SUCF PROJECT NO.: 071099-00

**REPLACE STOREFRONT AND EXTERIOR DOORS - BARTLE LIBRARY, UNIVERSITY UNION, AND
COUPER ADMINISTRATION BUILDING**

STATE UNIVERSITY OF NEW YORK
BINGHAMTON UNIVERSITY

ADDENDUM NO. 4

A-601A

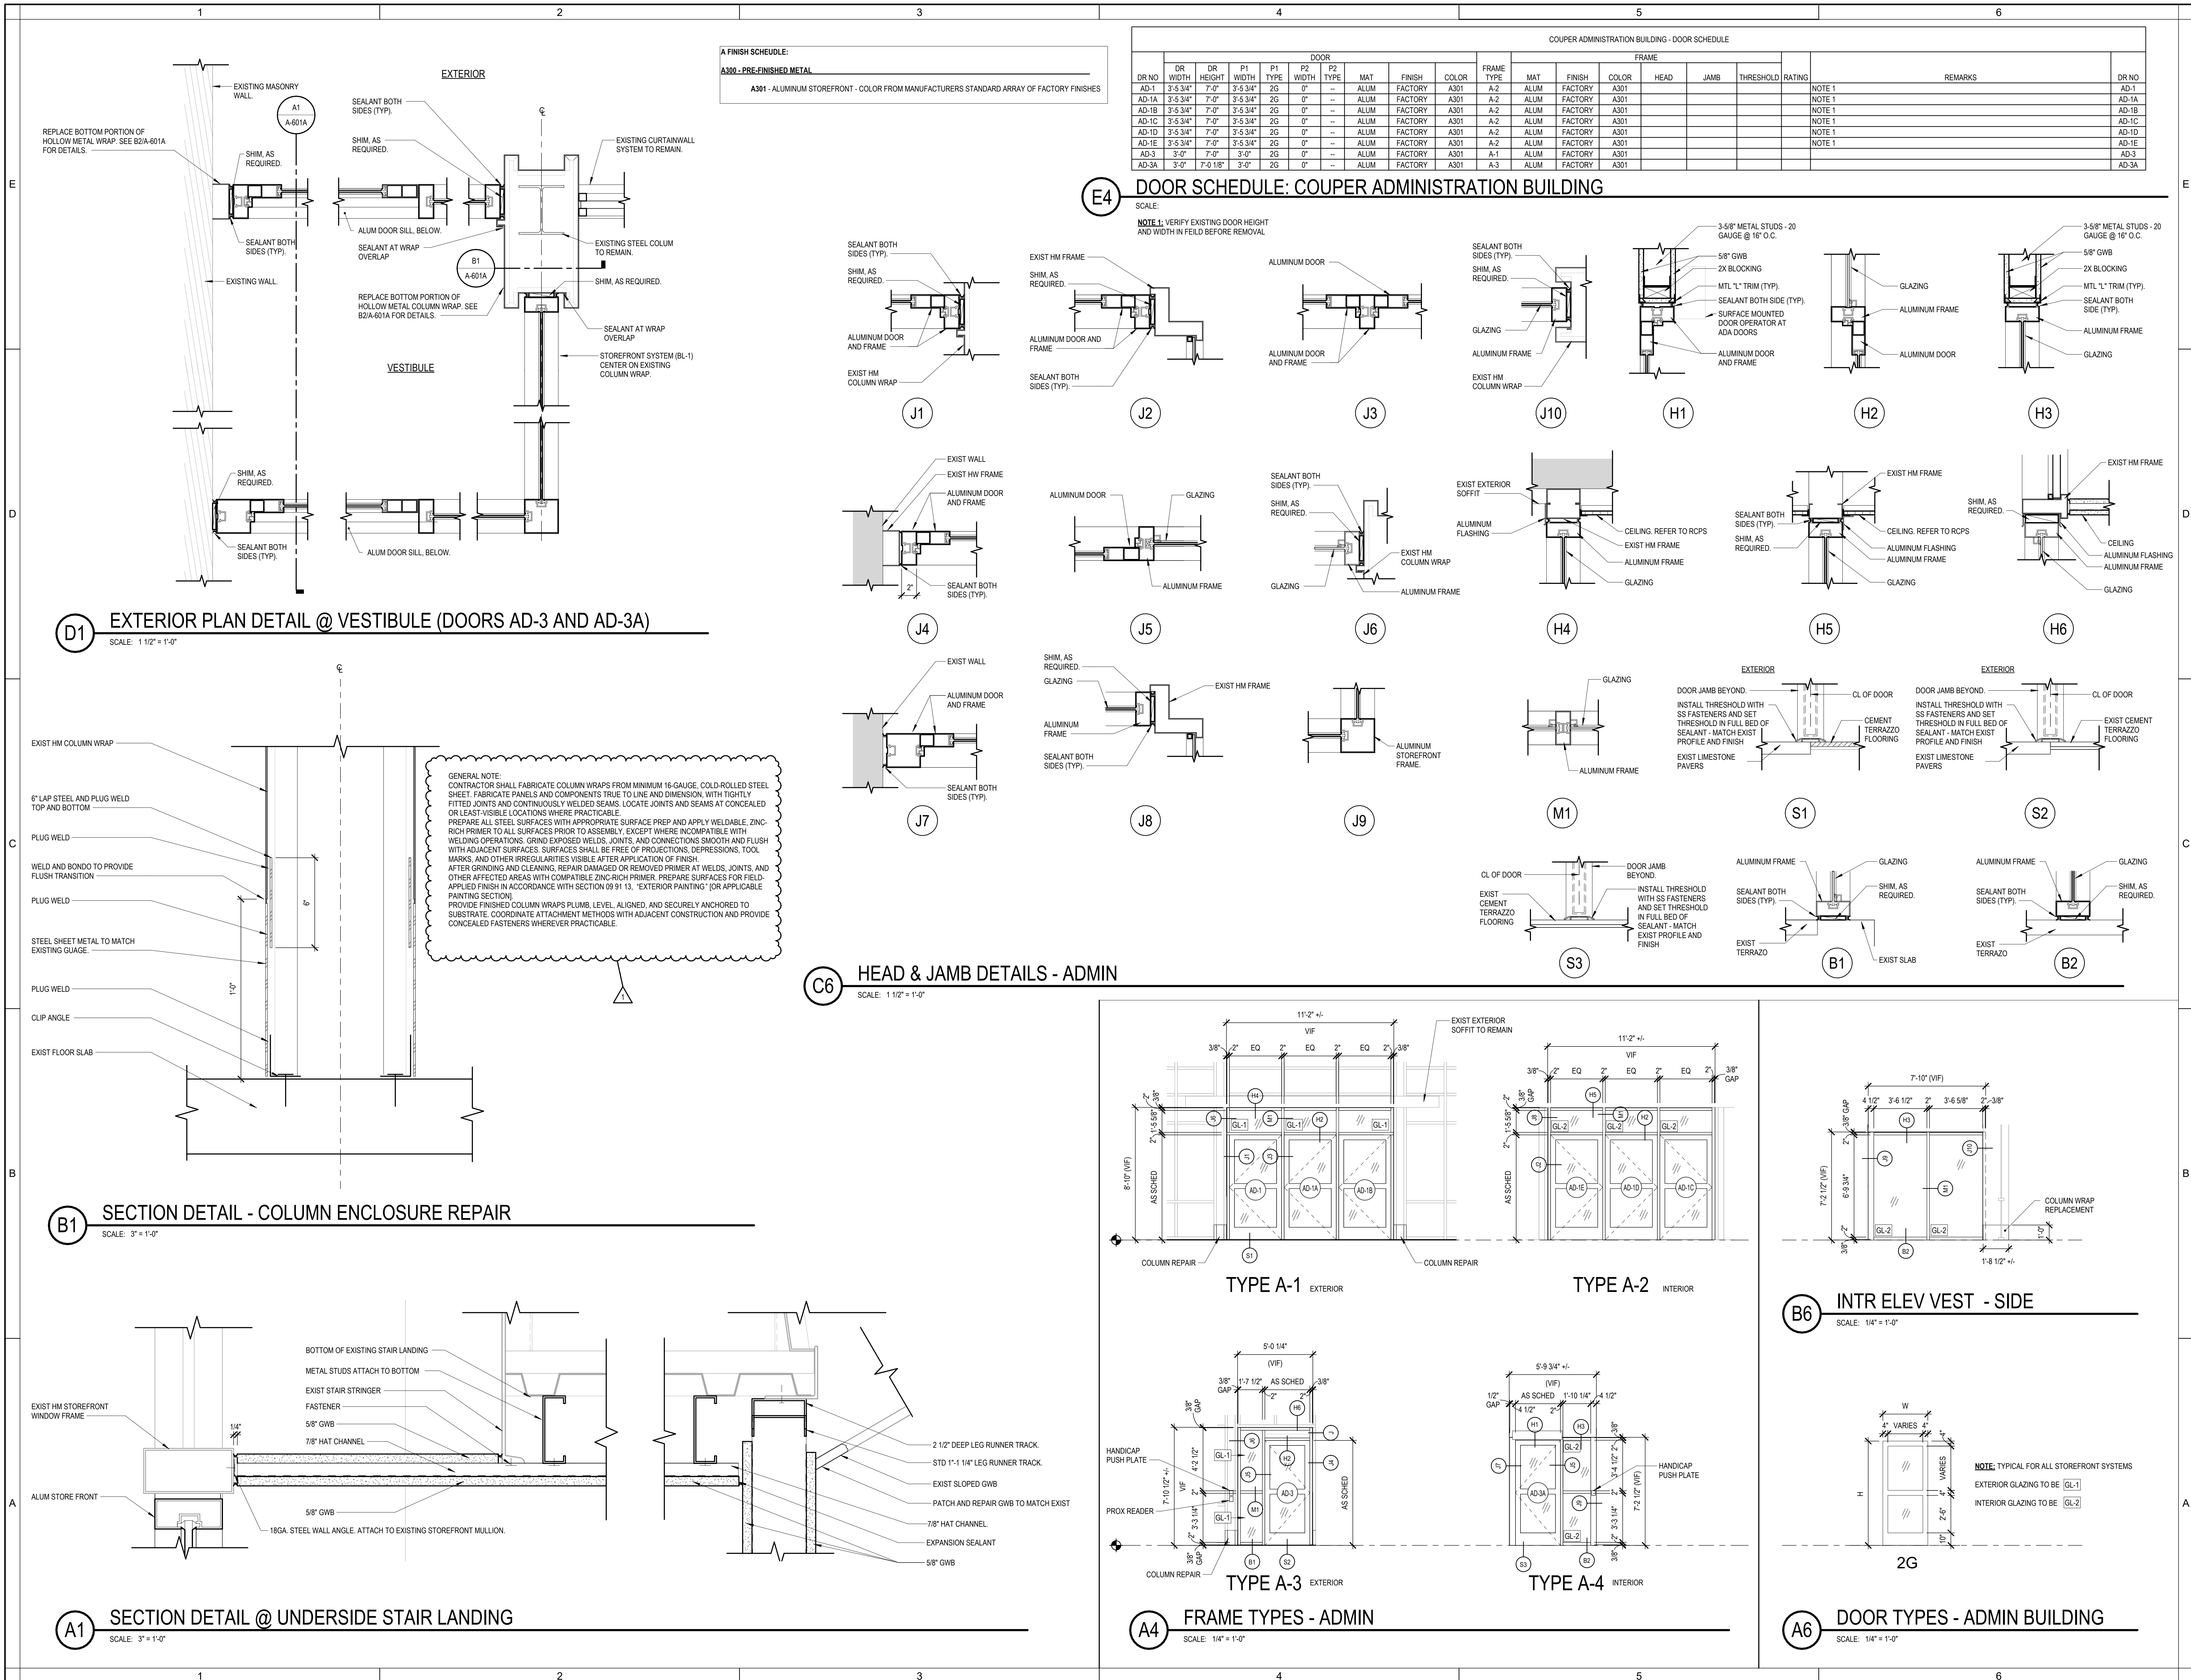
2.3.1. ADD General Note to B1/A-601A Section Detail – Column Enclosure Repair

GENERAL NOTE:

CONTRACTOR SHALL FABRICATE COLUMN WRAPS FROM MINIMUM 16-GAUGE, COLD-ROLLED STEEL SHEET. FABRICATE PANELS AND COMPONENTS TRUE TO LINE AND DIMENSION, WITH TIGHTLY FITTED JOINTS AND CONTINUOUSLY WELDED SEAMS. LOCATE JOINTS AND SEAMS AT CONCEALED OR LEAST-VISIBLE LOCATIONS WHERE PRACTICABLE.

PREPARE ALL STEEL SURFACES WITH APPROPRIATE SURFACE PREP AND APPLY WELDABLE, ZINC-RICH PRIMER TO ALL SURFACES PRIOR TO ASSEMBLY, EXCEPT WHERE INCOMPATIBLE WITH WELDING OPERATIONS. GRIND EXPOSED WELDS, JOINTS, AND CONNECTIONS SMOOTH AND FLUSH WITH ADJACENT SURFACES. SURFACES SHALL BE FREE OF PROJECTIONS, DEPRESSIONS, TOOL MARKS, AND OTHER IRREGULARITIES VISIBLE AFTER APPLICATION OF FINISH.

AFTER GRINDING AND CLEANING, REPAIR DAMAGED OR REMOVED PRIMER AT WELDS, JOINTS, AND OTHER AFFECTED AREAS WITH COMPATIBLE ZINC-RICH PRIMER. PREPARE SURFACES FOR FIELD-APPLIED FINISH IN ACCORDANCE WITH SECTION 09 91 13, "EXTERIOR PAINTING" [OR APPLICABLE PAINTING SECTION].

PROVIDE FINISHED COLUMN WRAPS PLUMB, LEVEL, ALIGNED, AND SECURELY ANCHORED TO SUBSTRATE. COORDINATE ATTACHMENT METHODS WITH ADJACENT CONSTRUCTION AND PROVIDE CONCEALED FASTENERS WHEREVER PRACTICABLE.
